Sinclair College  
**Building 14 – EMS Classrooms & Sim Lab**  
FAC 24-28X  
Dayton, OH

## **ADDENDUM 02**

**Date of Addendum:** February 10, 2025

### **To the Drawings and Specifications for:**

**A-102**

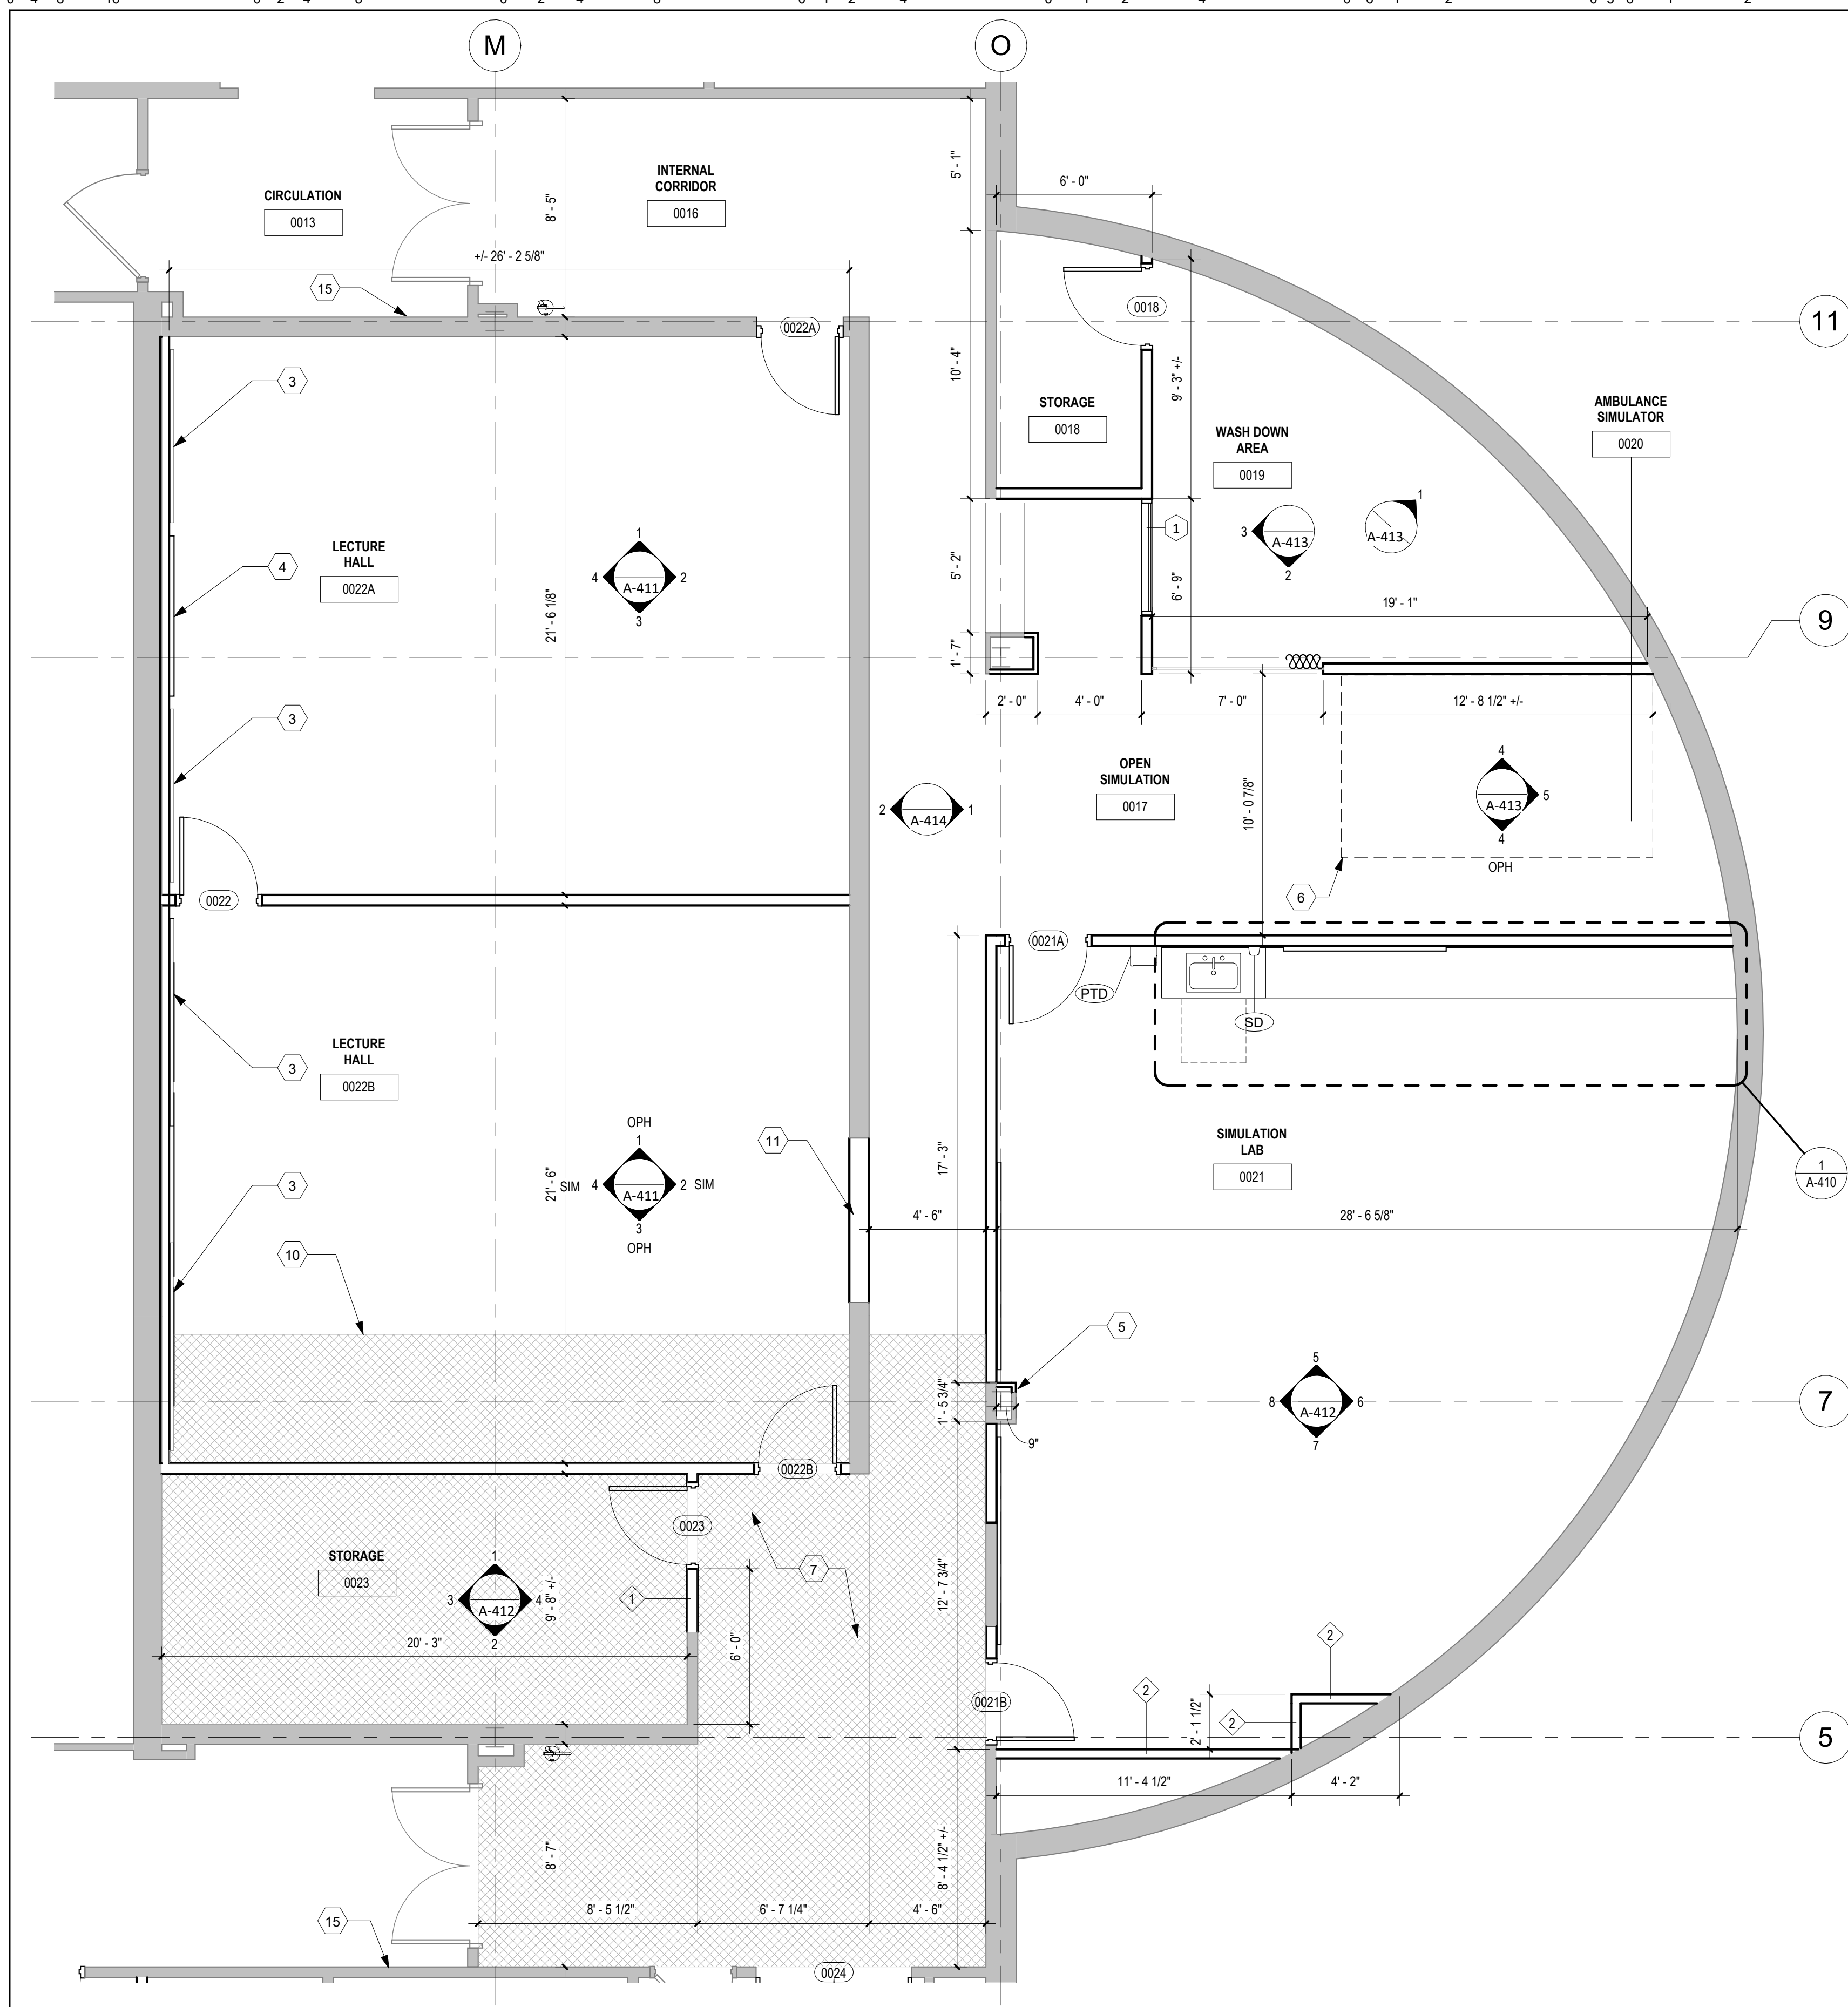
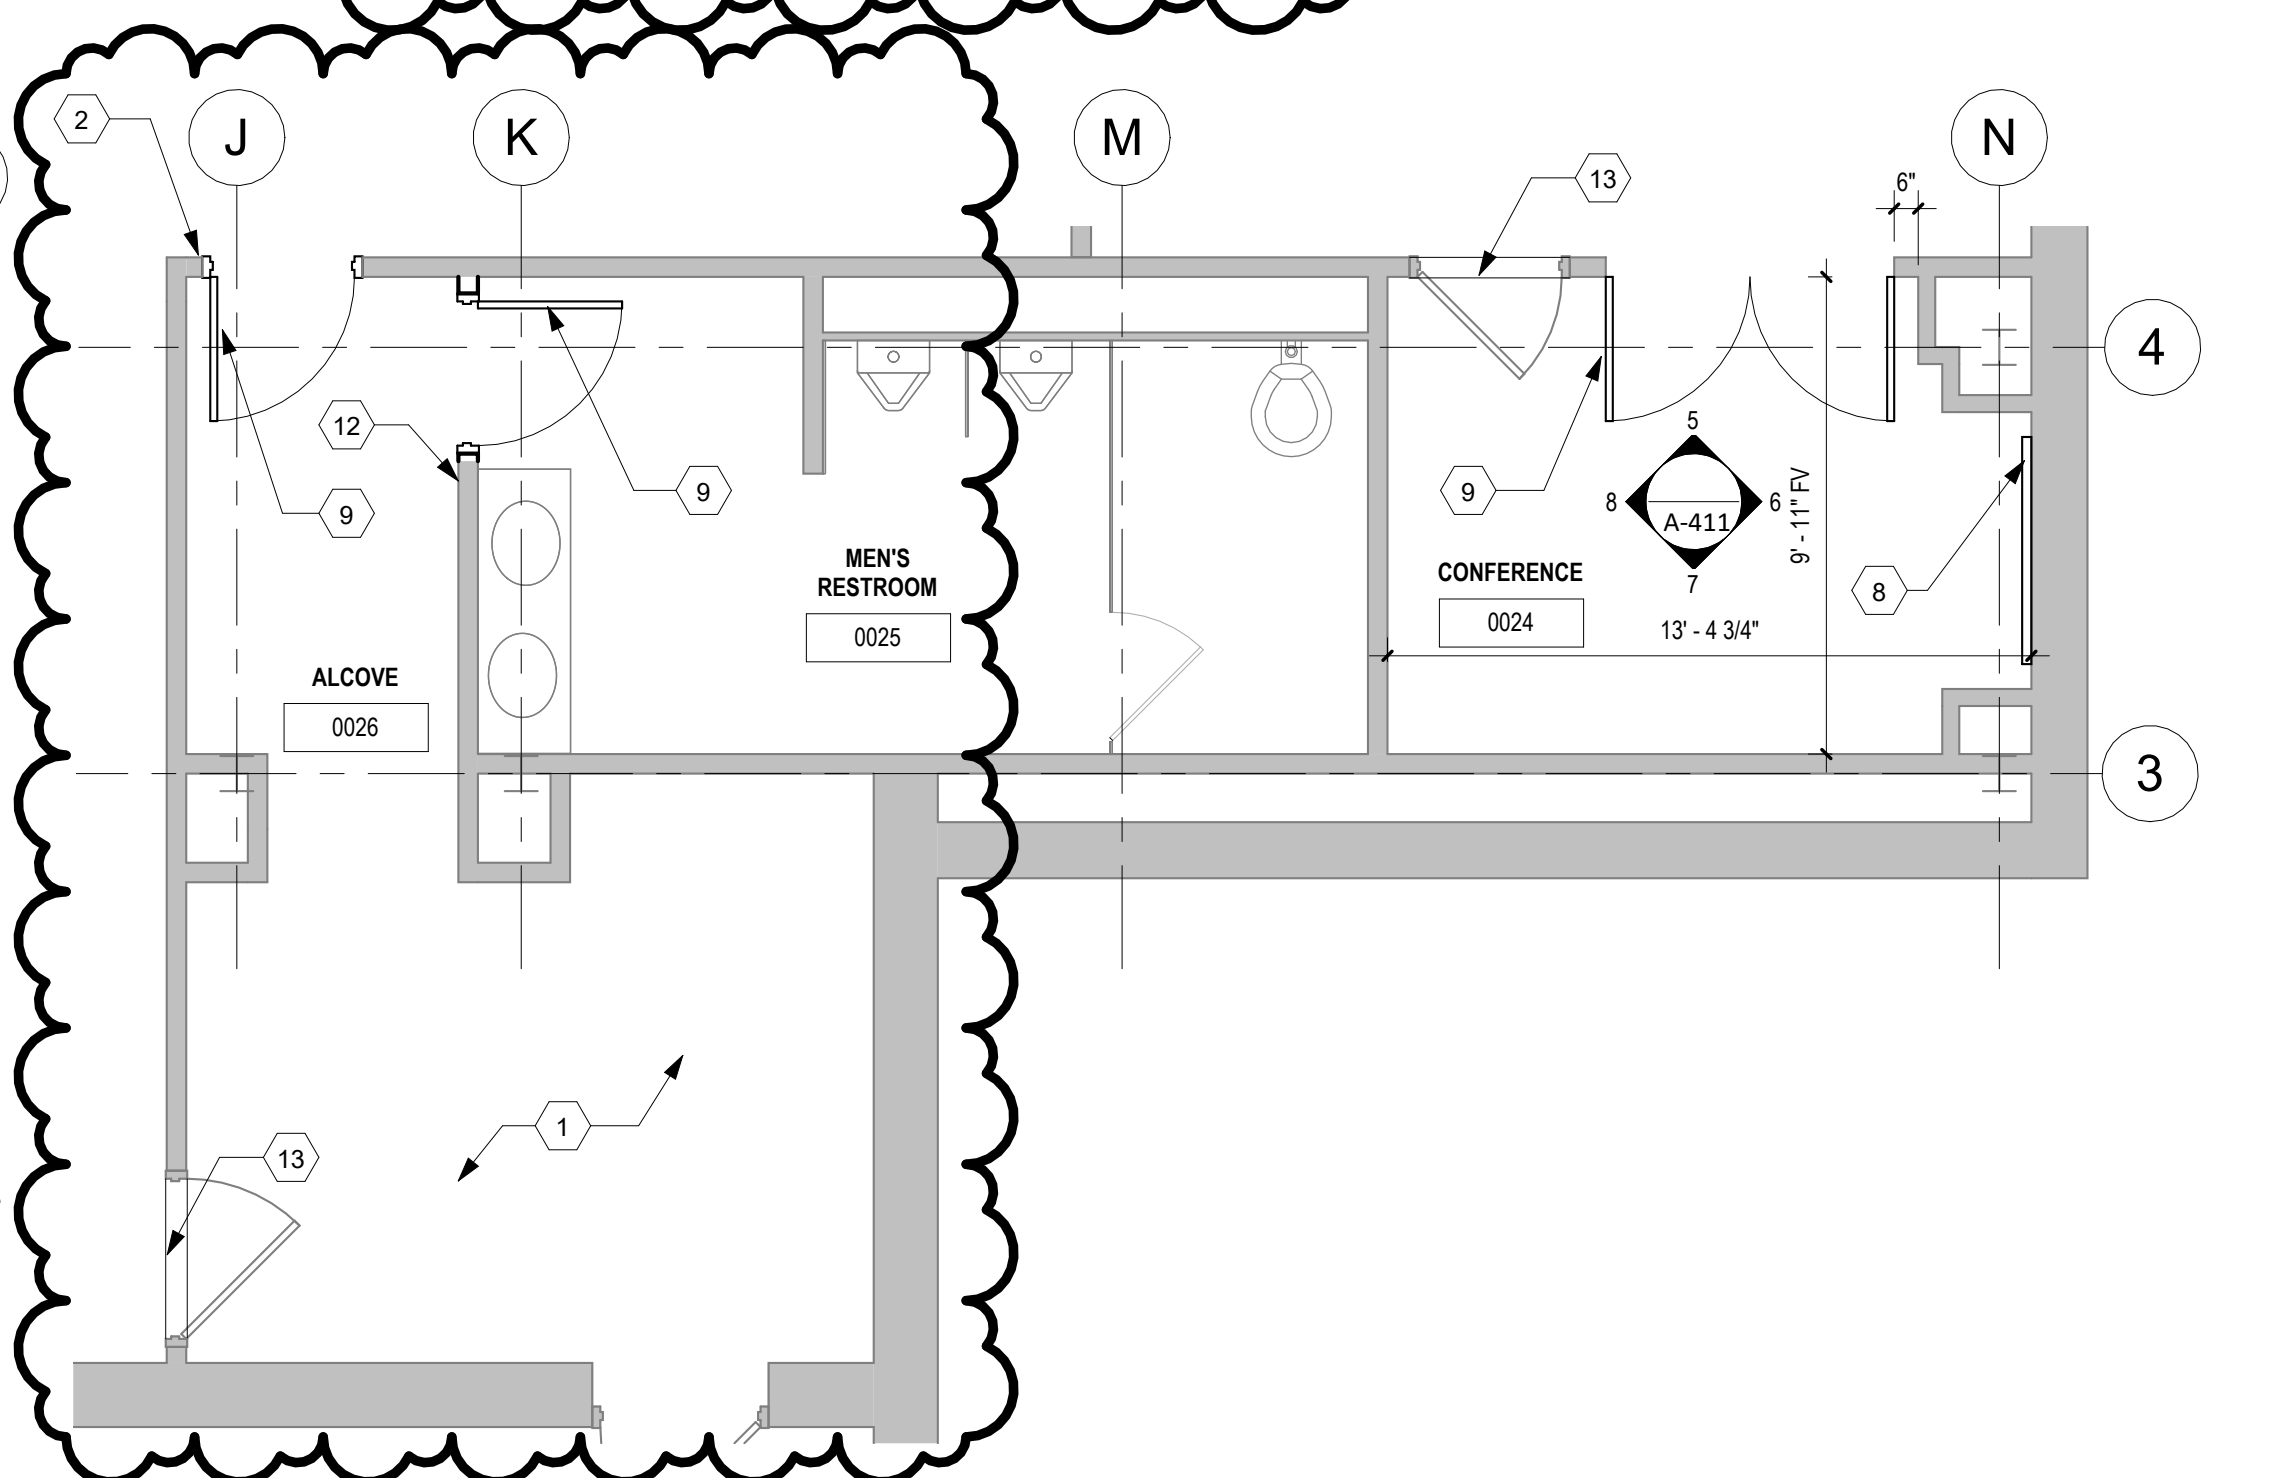
2. Sheet A-102 ENLARGED LOWER LEVEL FLOOR PLANS; Replace A-102 in its entirety with attached sheet A-102.
  - a. Revise coded notes 1, 2, 3, 4, 8, 9, 11, 12, 13.

- b. Extend plan detail 2, ENLARGED PLAN – ROOMS 0024 TO 0026.
3. Sheet A-411 LOWER LEVEL INTERIOR ELEVATIONS:
  - a. Detail 4 – Revise notes that read “MKBD-1” to read “MKBD 6’-8” X 4’-0””

- BID ALTERNATE - REPLACE EXISTING CARPET TILE WCPT-1. BASE BID: NO WORK.
- BID ALTERNATE - PATCH, PRIME, PAINT GYP IN AREA OF NEW OPENING TO MATCH EXISTING. BASE BID: NO WORK.

- PROVIDE MKBD MOUNTED AT 36" AFF, REFER TO ELEVATIONS
- PROVIDE FLAT PANEL, REFER TO ELEC & TECH DWGS.
- PATCH EXIST GYP COLUMN
- AMBULANCE SIMULATOR PROVIDED BY OWNER. GC TO COORDINATE INSTALLATION WITH VENDOR. FIXED PARTITIONS MAY NEED TO BE CONSTRUCTED ON BOTH SIDES AFTER AMBULANCE SIMULATOR INSTALLATION IS COMPLETE. REFER TO MEPT DWGS FOR ADDITIONAL COORDINATION.

- EXISTING RAISED FLOOR TO REMAIN AS INDICATED BY HATCH REGION. REPAIR OR REPLACE ANY DAMAGED TILES TO MATCH EXISTING. REFER TO DETAIL 3/A-102.
- PROVIDE FLAT PANEL, REFER TO ELEC & TECH DWGS.

- BID ALTERNATE - PROVIDE DOOR(S), FRAME & ASSOCIATED HARDWARE TO MATCH EXISTING. BASE BID: NO WORK.
- EXTENT OF EXISTING RAISED FLOOR.
- INSTALL SALVAGED ACOUSTICAL PANELS. COORDINATE SALVAGED PANELS TO BE USED WITH A/E.

- BID ALTERNATE: PROVIDE ADA DOOR PUSH BUTTON OPERATOR. BASE BID: NO WORK.
- BID ALTERNATE - PATCH, PRIME, PAINT GYP PARTITION AT REMOVED OPENING TO MATCH EXISTING. BASE BID: NO WORK.

- PROVIDE CARD READER. REFER TO MEPT DRAWINGS.
